From: MP Whalen (Generation - 3) [mp.whalen@dom.com]
Sent: Wednesday, August 07, 2013 3:59 PM
To: Sreenivas, V
Subject: Relief Request RAI from NRC Conference Call August 2 2013
Attachments: 2013-08-07 RAI Response Update .docx

Friday, 8/2/13, NRC conference call regarding weld SW41. In our 2010 submittal on page 44 we discuss Weld SW41 and only getting 35% coverage. In the last sentence we take credit for one other weld on the segment with complete coverage that provides an acceptable alternative. The NRC is looking for two items:

Figure 2-12
Examination Zones for Butt-Welded Lines Vertically Upward from RCS Piping

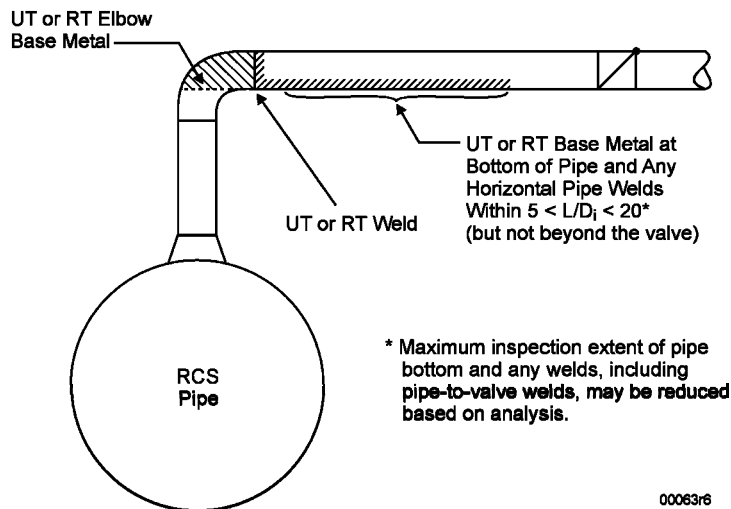
1. Information on the other welds inspected this interval with >90 coverage with regards to it being in the same risk informed category, same failure mechanism, and same filler metal.

EPRI developed MRP-146, "Materials Reliability Program Management of Thermal Fatigue in Normally Stagnant Non-Isolable Reactor Coolant System Branch Lines," in order to provide screening, evaluation, monitoring, inspection, operations, maintenance, and modification guidance to enable utilities to avoid thermal fatigue cracking due to valve in-leakage or turbulence/swirl penetration effects in affected lines. Although weld SW-41 is classified in the Risk-Informed ISI Program as R-A / R1.11, subject to thermal fatigue, this branch connection weldolet at the top of the RCS pipe is not considered for evaluation under the MRP-146 guidelines.
